CITY of NOVI CITY COUNCIL

Agenda Item 1
January 11, 2016

SUBJECT: Consideration of tentative approval of the request of Hunter Pasteur Homes for Dunhill Park, JSP 15-13, with Zoning Map Amendment 18.711, to rezone property in Section 32, located at the northwest corner of Beck Road and Eight Mile Road from RA (Residential Acreage) to R-1 (One-Family Residential) with a Planned Rezoning Overlay (PRO); and corresponding concept plan. The property totals 23.76 acres and the applicant is proposing to construct a 31-unit single family residential development in a cluster arrangement with frontage on and access to Eight Mile Road.

CONCEPT PLAN

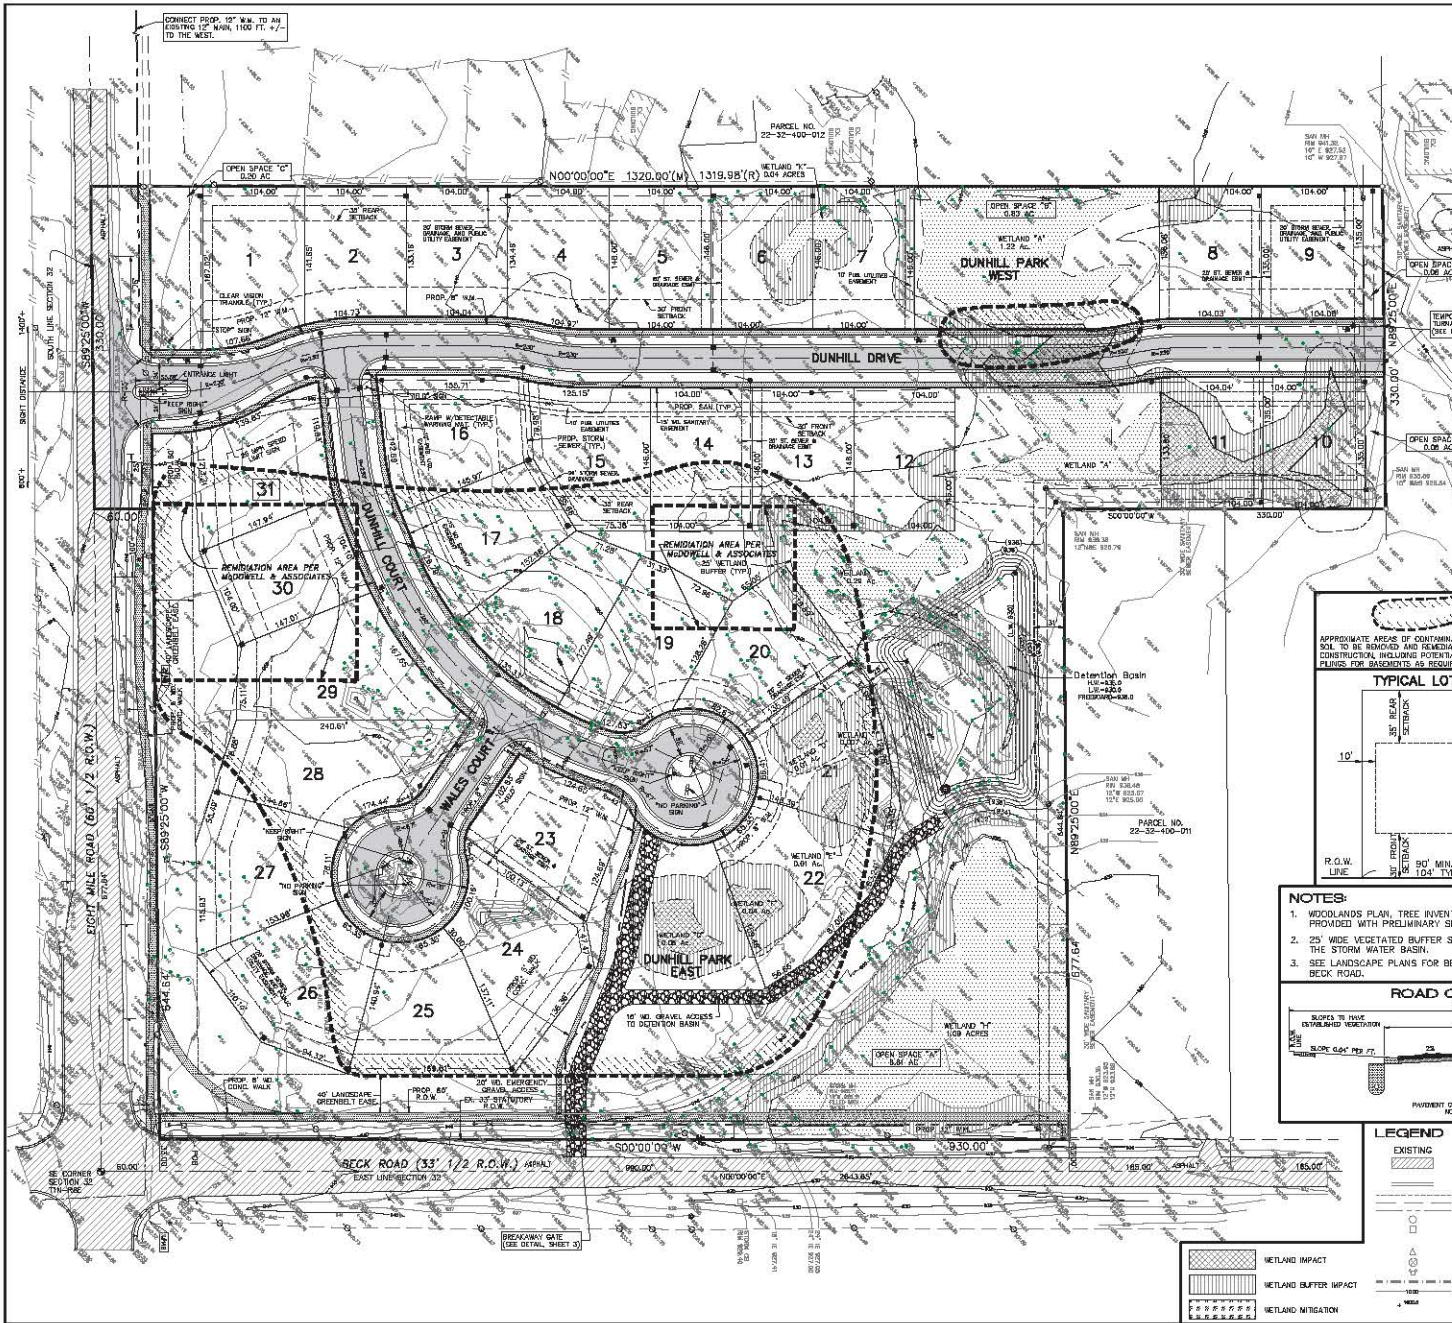
various fill material. Contaminated debris includes buried fuel oil tanks. The concept plan shows large circle areas that are the potential areas of debris; the smaller circles are the areas that are known to have debris. Any contamination found during excavation will be dug out and properly disposed.

PLANNED REZONING OVERLAY (PRO) PLAN

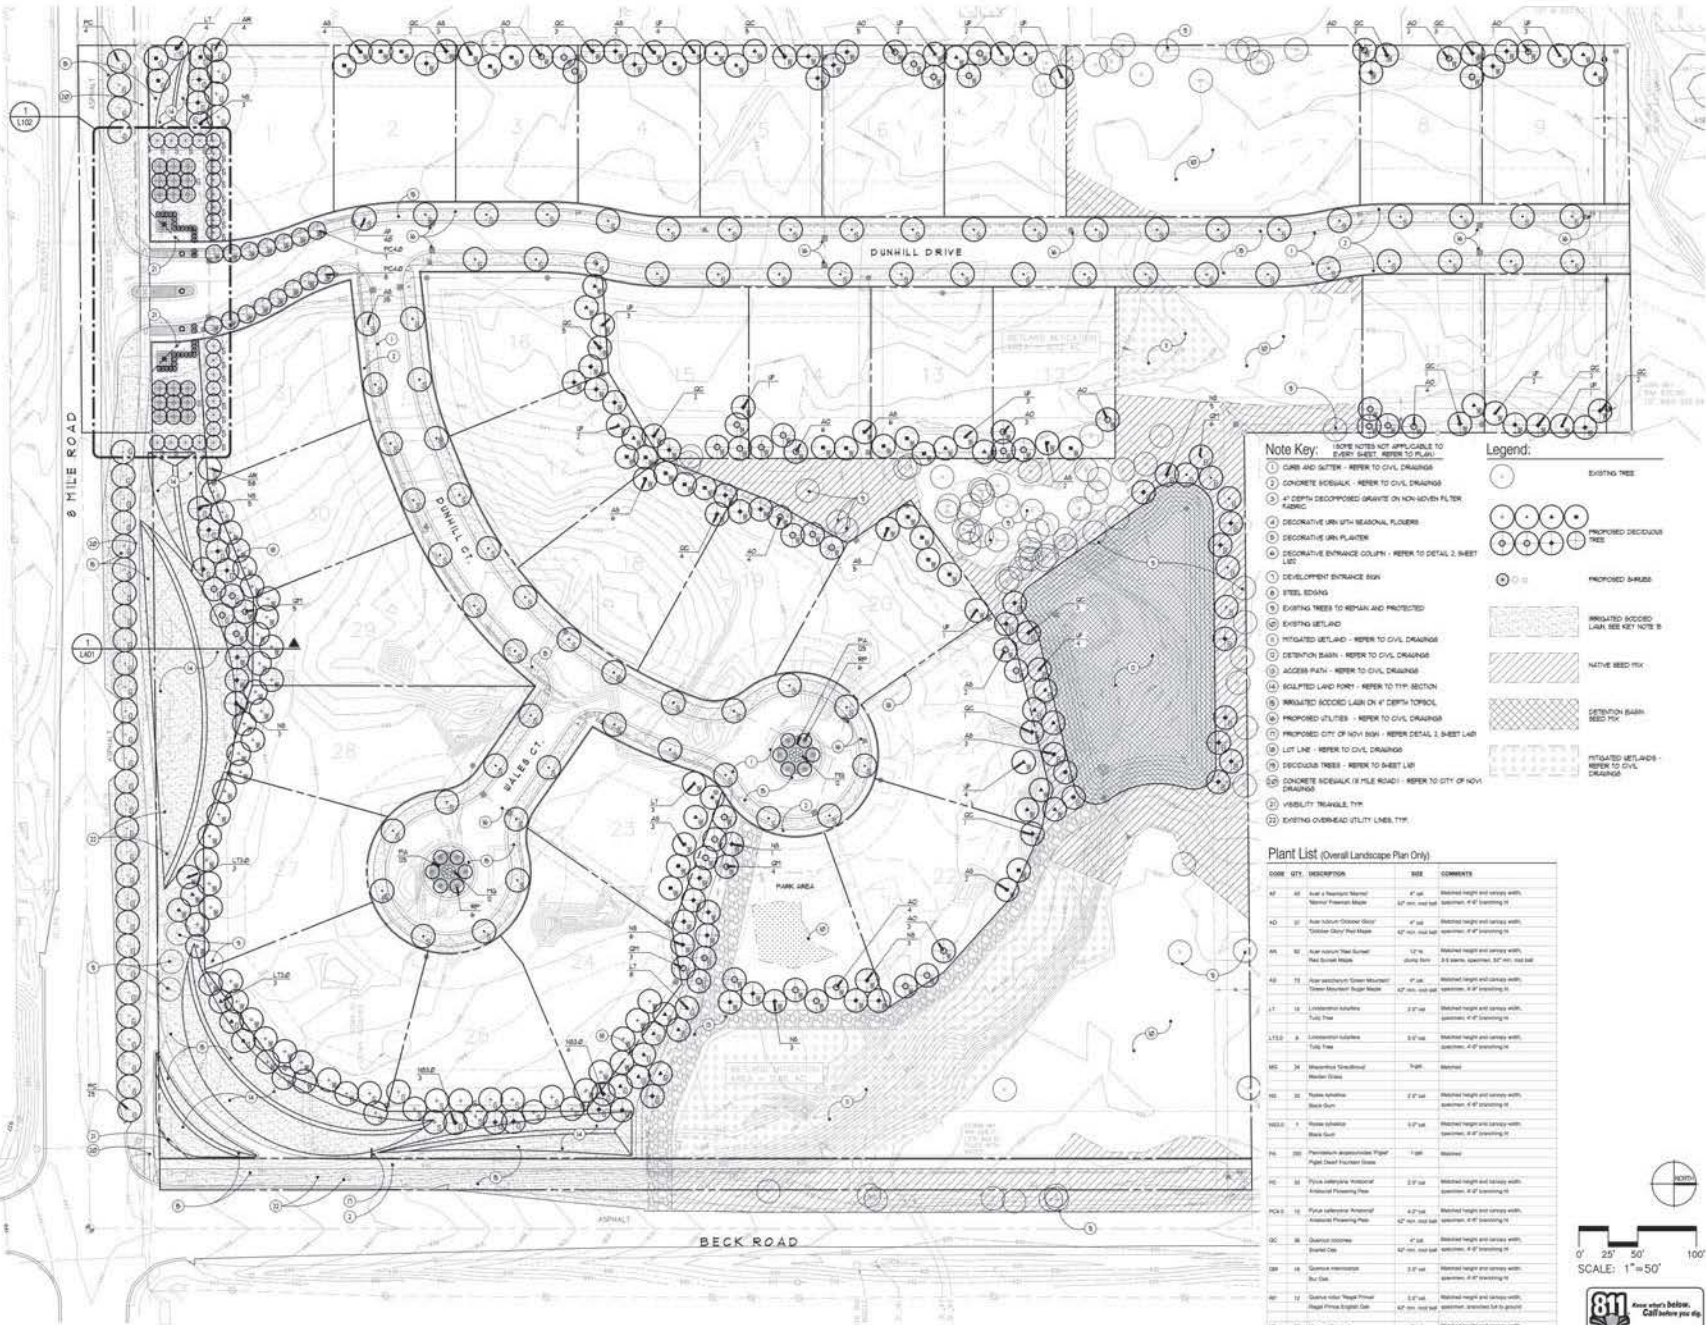
2. Setbacks: The **minimum side yard setback** for a single-family dwelling in this district is 15 feet (with an aggregate of 40 feet). The applicant has proposed a minimum 10 foot side yard setback (with an aggregate of 30 feet). These deviations should be included in the PRO Agreement and should be updated on Sheet 2. Staff supports this deviation.

2. **Setbacks:** The minimum side yard setback for a single-family dwelling in this district is 15 feet with an aggregate of 40 feet. The applicant has proposed a minimum 10 foot side yard setback (with an aggregate of 30 feet). These deviations should be included in the PRO Agreement and should be updated on Sheet 2.

This comment has not been adequately addressed. The PRO Plan (Sheet 2) does not appear to clearly indicate the quantity or the location of any proposed wetland mitigation areas. In a response letter dated October 23, 2015, the applicant states that no changes have been made to the proposed wetland impacts or mitigation from the previous plan submittal. However, this response letter also states that the plans no longer propose to fill the small wetland (Wetland G, 0.06-acre) where Lot 23 was located. The letter also states that wetland mitigation is provided for all city regulated wetlands on the site at a ratio of 1.5 (mitigation) to 1 (fill). This information does not appear to be consistent with what has been indicated on the current Plan (including the Wetland Impact table on Sheet 2). Based on the current Plan, 0.735-acre of wetland mitigation would be required. The applicant is encouraged to review and revise the Plan as necessary.
